REMARKS

Figure 2

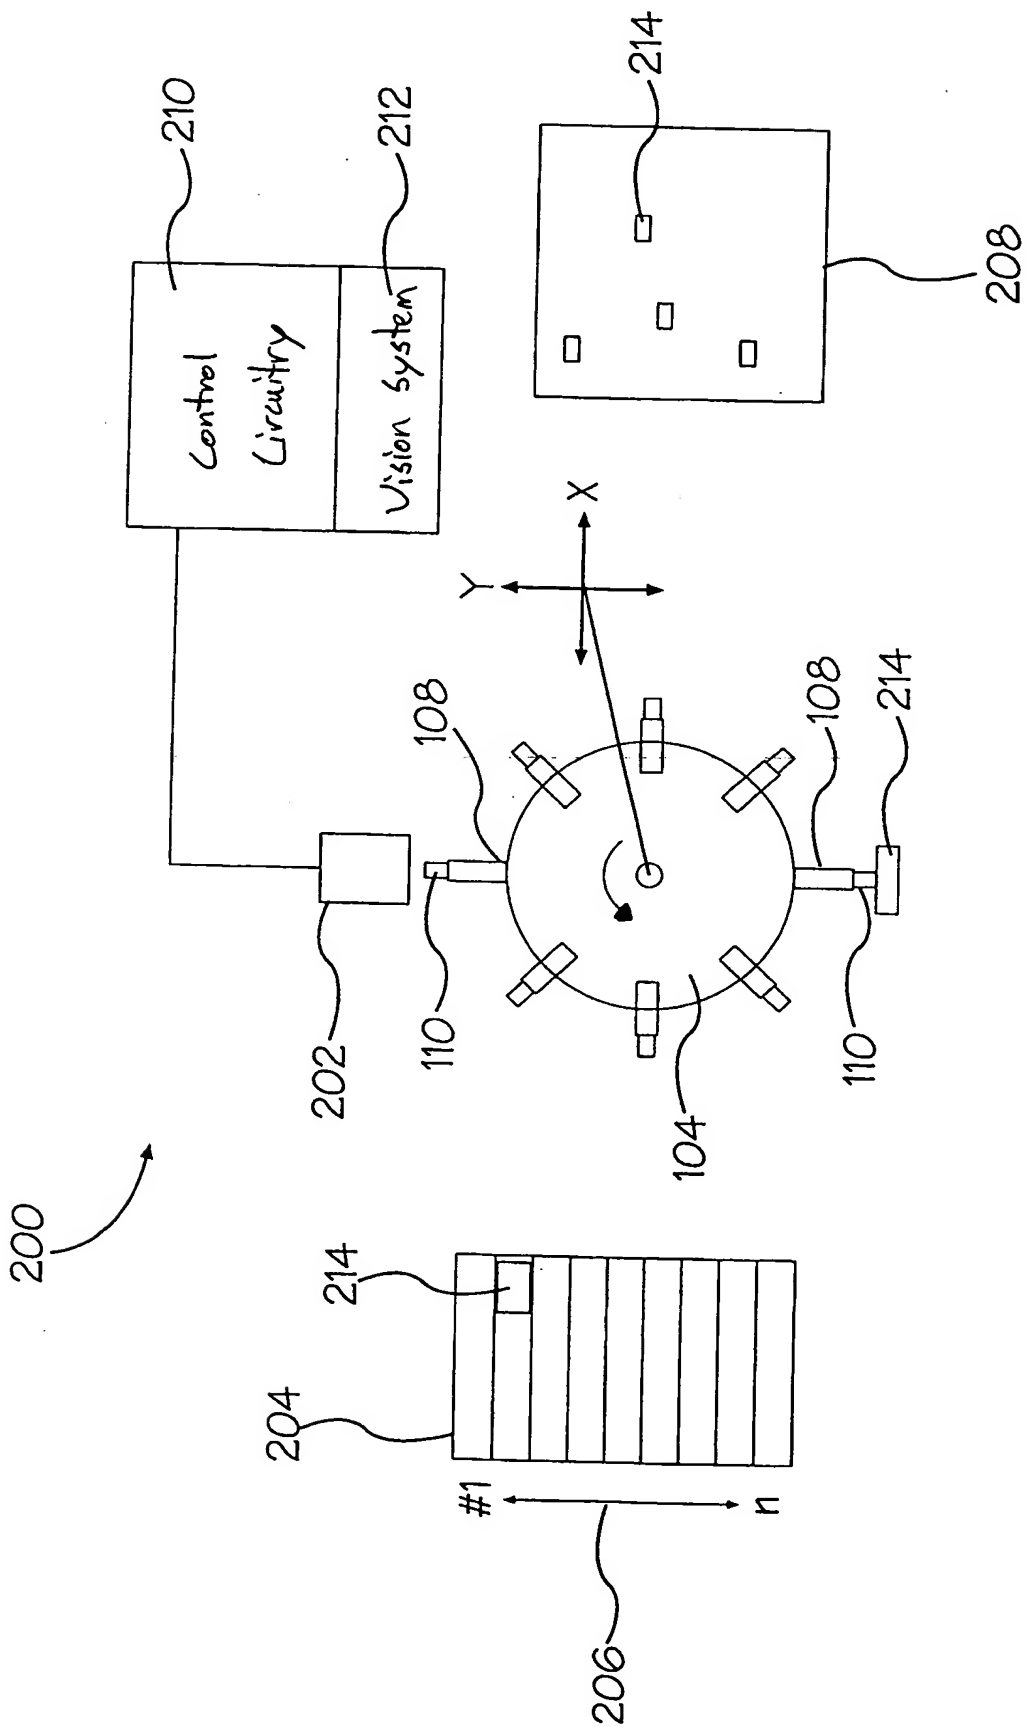
The drawings were objected to because in FIG. 2 box elements 202, 210 and 212 should be identified with appropriate legends. Applicant has included herewith replacement sheets intended to bring the drawings into allowance. Included anew in FIG. 2 are legends for box elements 210 and 212. However box element 202 numerically referencing at least one camera has not been modified with a legend due to inconvenience relative to the size of the box element 202. Also included in FIG. 2 is the tip of an arrow showing direction of rotation of rotatable frame 104. In addition, FIG. 3 has been modified to more accurately depict a timing diagram of vacuum nozzle image acquisition and processing during the placement cycle time in accordance with the inventive method. The modifications are intended to bring the depiction of FIG. 3 into more accurate compliance with the specification, so that “as may be seen, image acquisition and processing (calibration) for each vacuum nozzle are always completed within a single pick or place cycle.” (See Specification, page 9, lines 1-3).
